Re: 33 Bayberry Road – Site Plan for Bayberry Armonk, LLC.
Armonk, NY (100.03-1-6)

As an addendum to this letter, we attach our responses to the March 7, 2023 RPRC comments dated April 24, 2023.

We received comments from the RPRC dated March 7, 2023 and offer the following information:

PROPOSED SITE PLAN - OVERALL

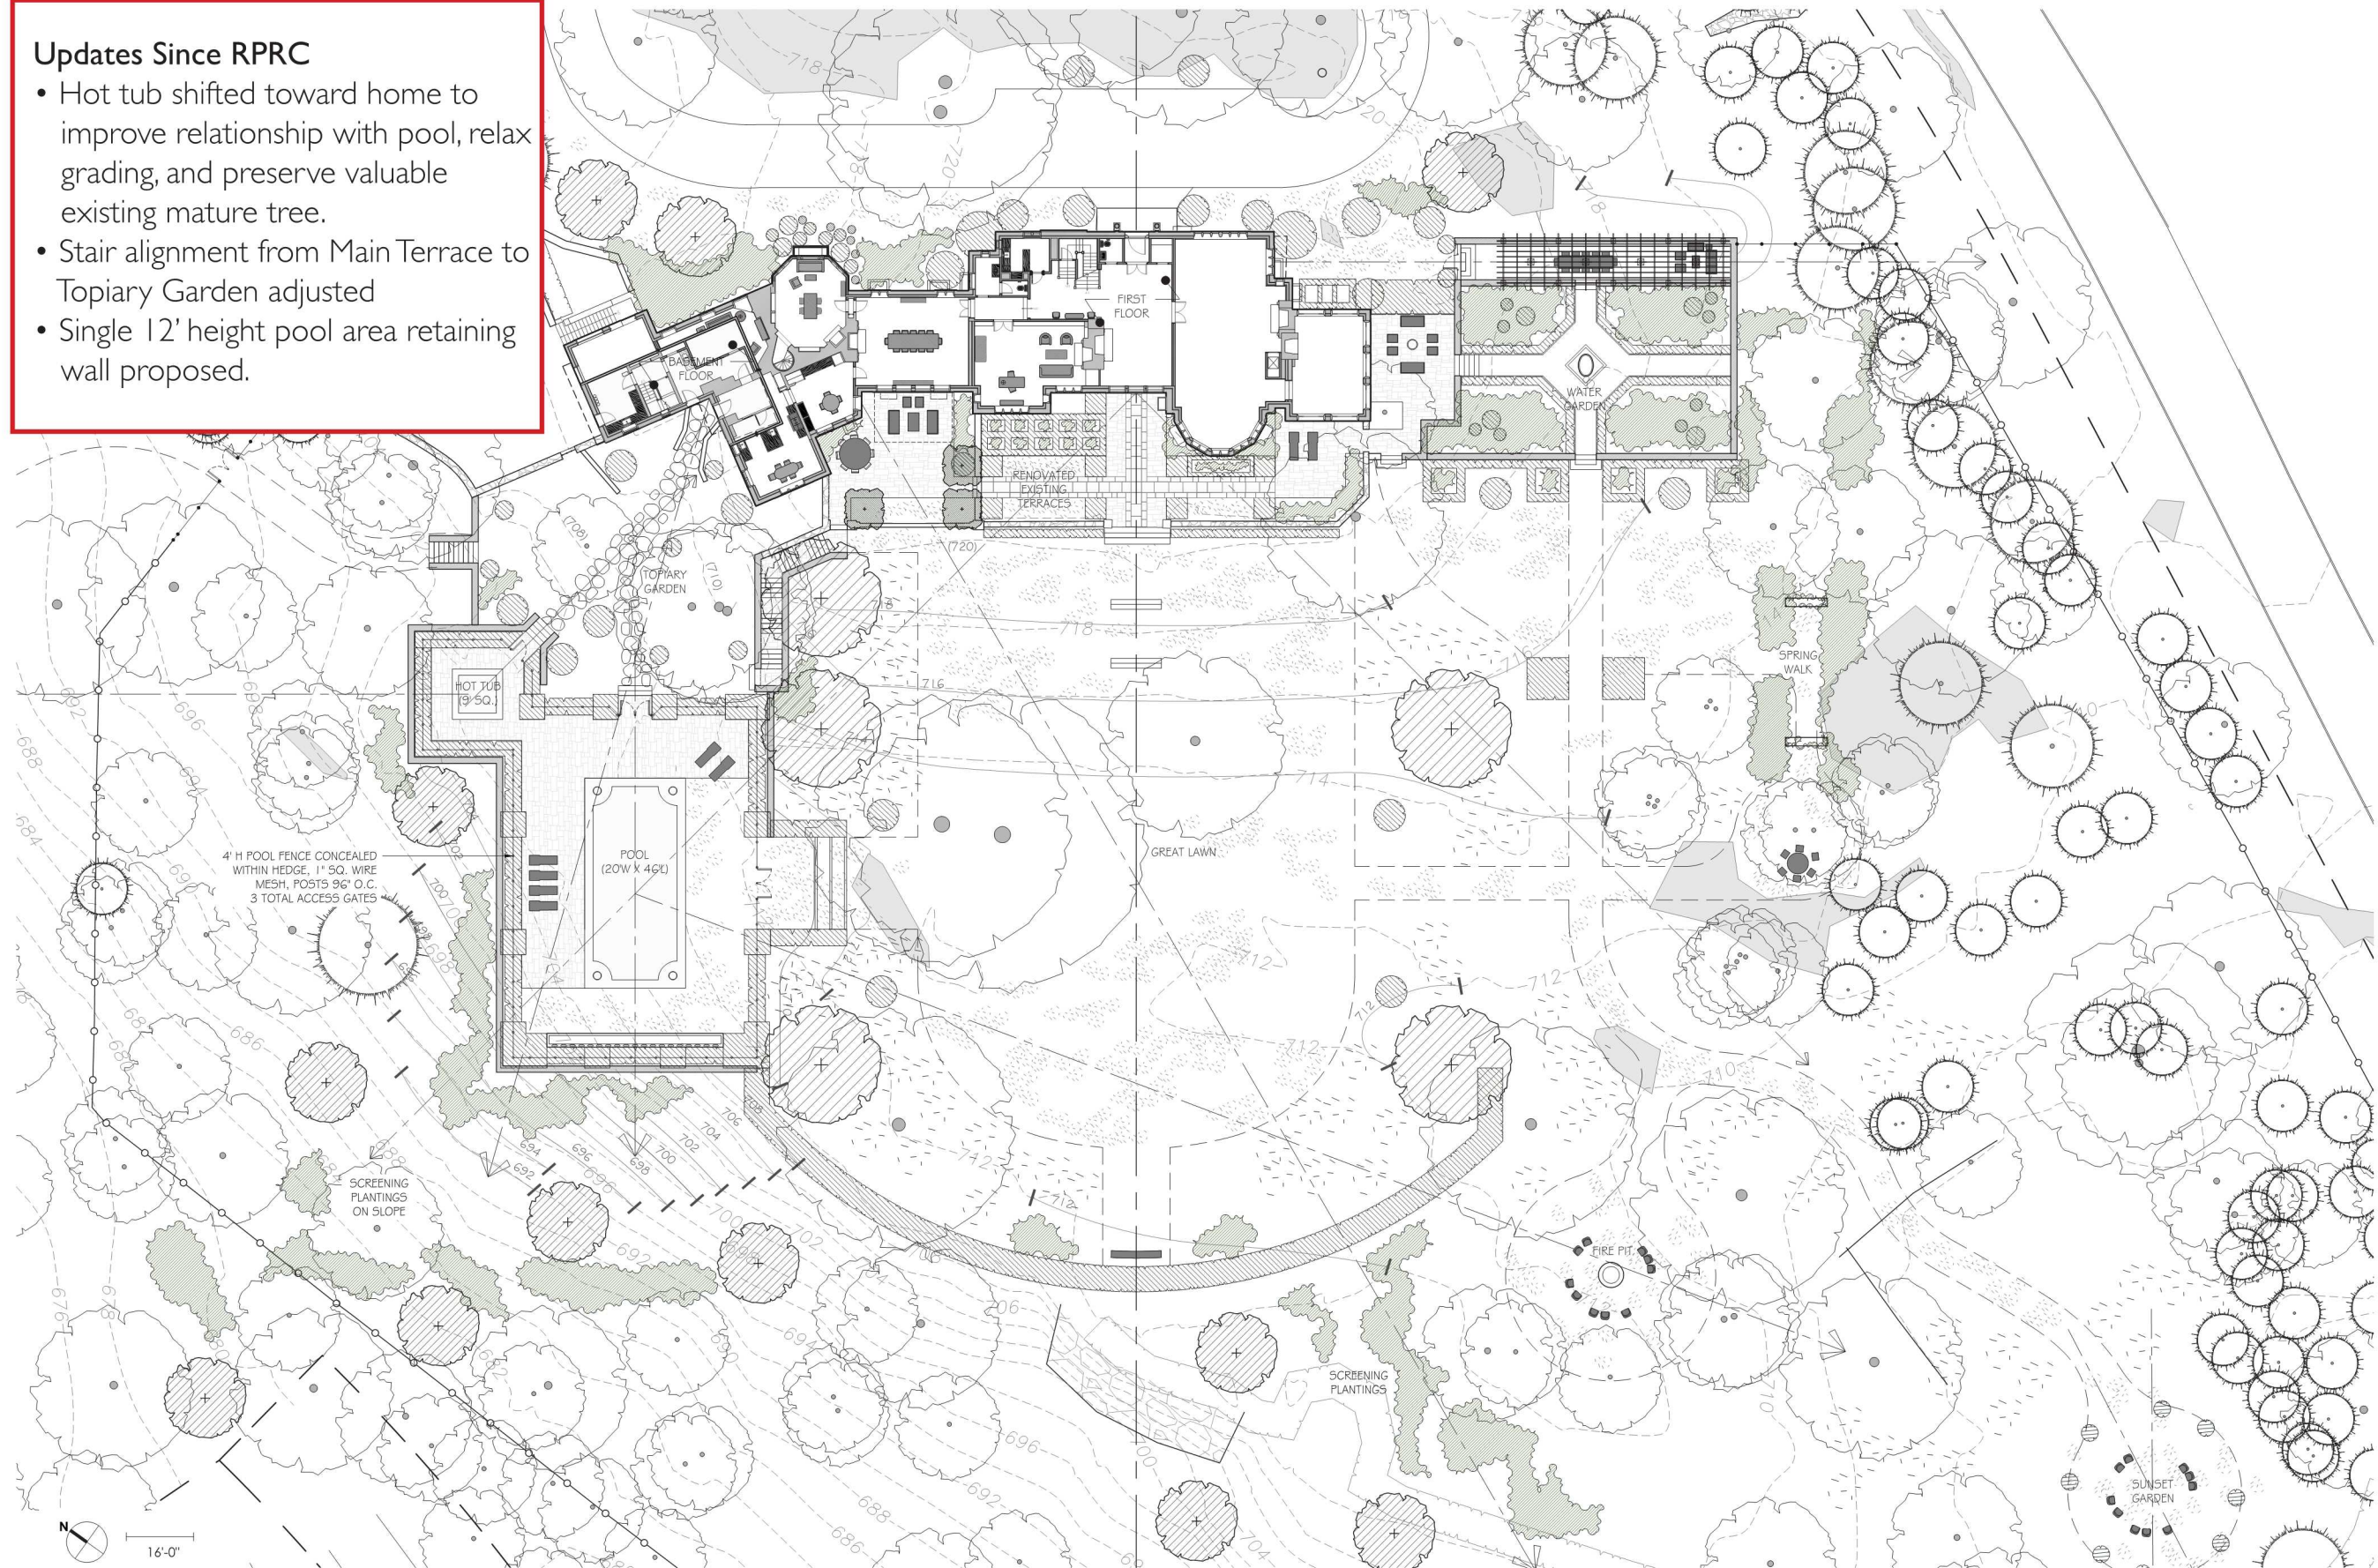
The location and orientation of the proposed pool results in a series of retaining walls. It is recommended that the pool be rotated so that grading/walls can be significantly reduced by avoiding chasing the grade down the hill.

- Hot tub shifted toward home to improve relationship with pool, relax grading, and preserve valuable existing mature tree.
- Stair alignment from Main Terrace to Topiary Garden adjusted
- Single 12' height pool area retaining wall proposed.

1 POOL FENCE - ELEVATION
1/2" = 1'-0"

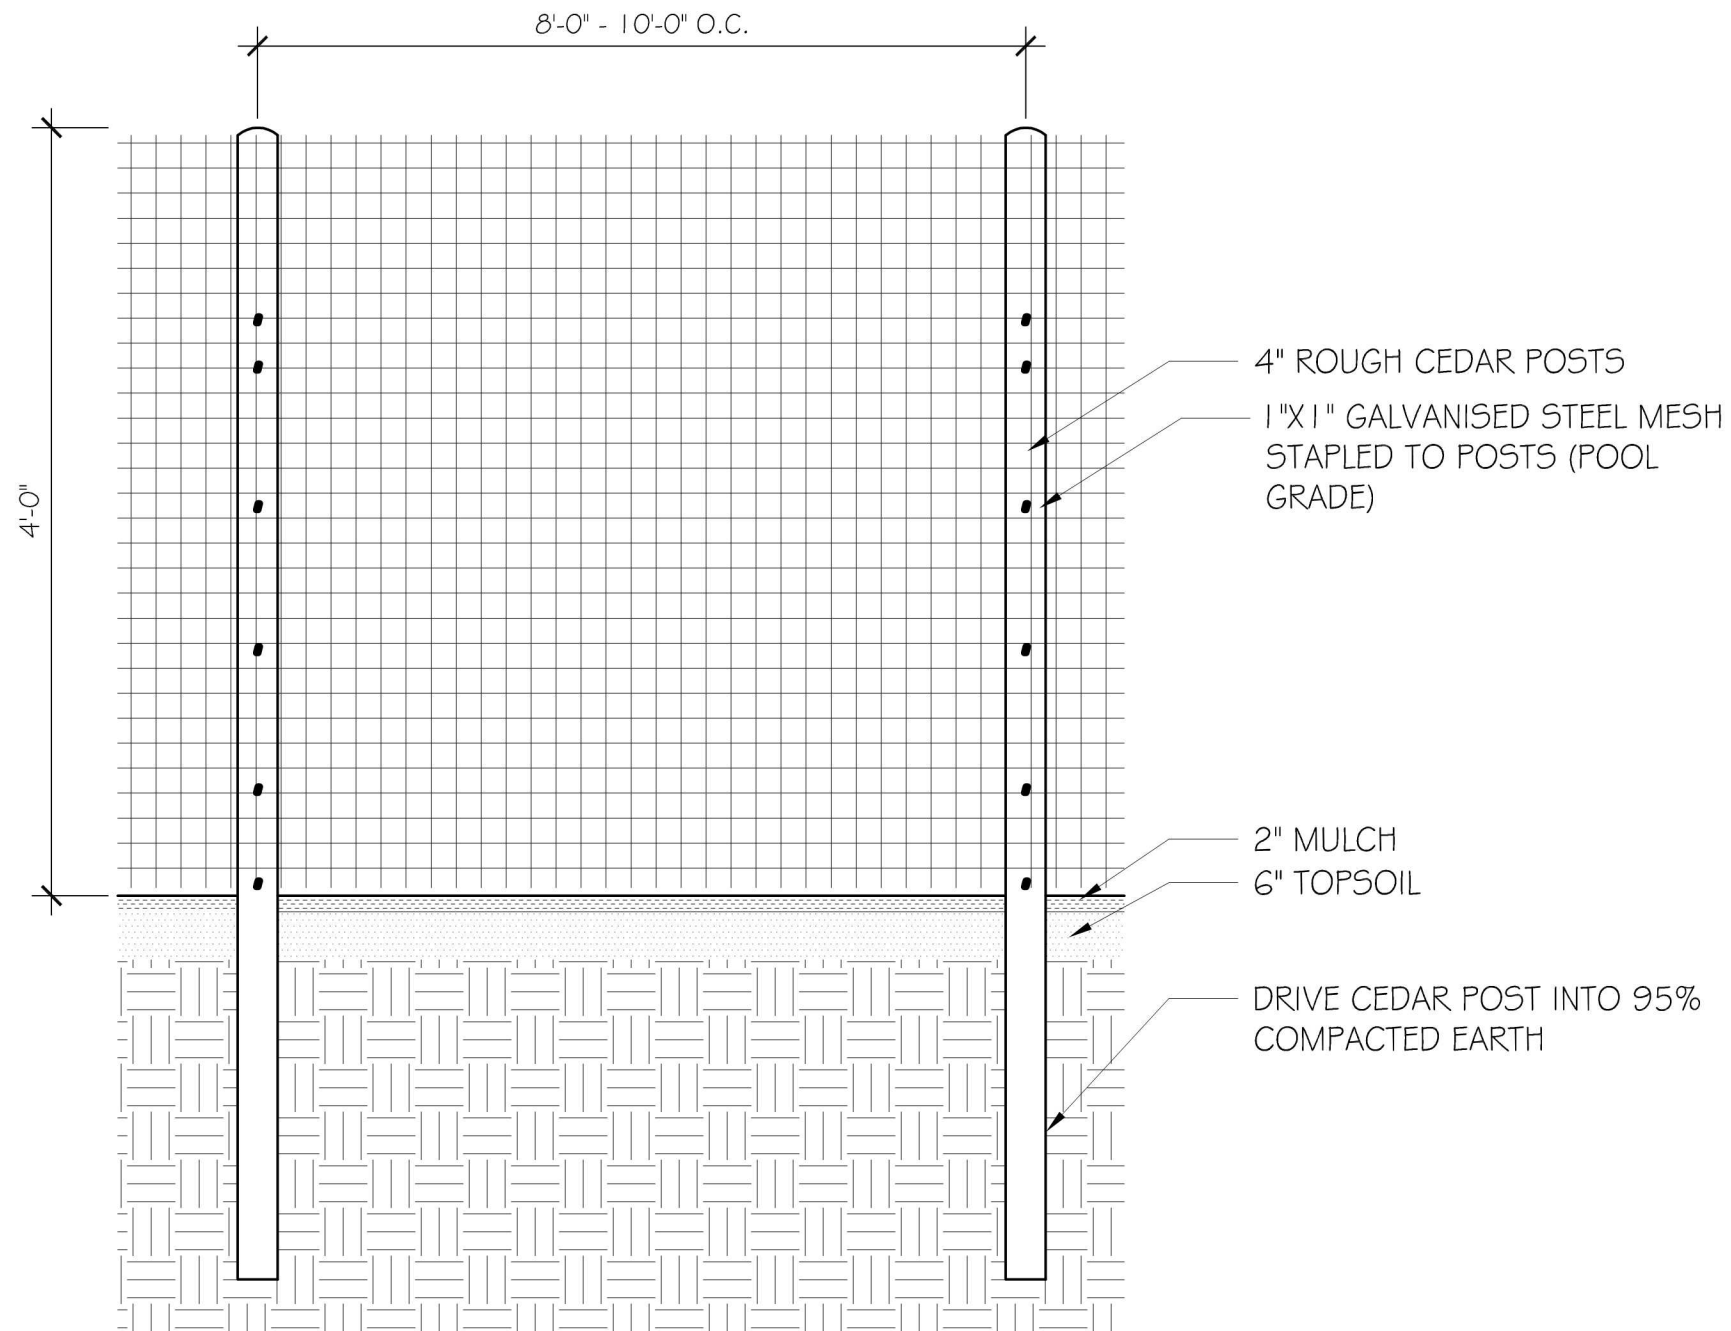
Provide fence and gate details, including height, material, post installation, etc. The plan shall delineate the limits of fence type and locate all gates. The plan shall note that the pool fence and gate shall comply with all applicable NYS Building Code requirements.

Response: Fencing is shown on the Landscaping Plan, supplementary materials.

NOTE: ALL POOL FENCING IS TO BE COMPLIANT WITH NEW YORK STATE BUILDING CODE REQUIREMENTS FOR SWIMMING POOL BARRIERS.

NOTE: MAINTAIN 4' FENCE OR WALL HEIGHT AROUND ENTIRE POOL

(This drawing included upon request by RPRC)
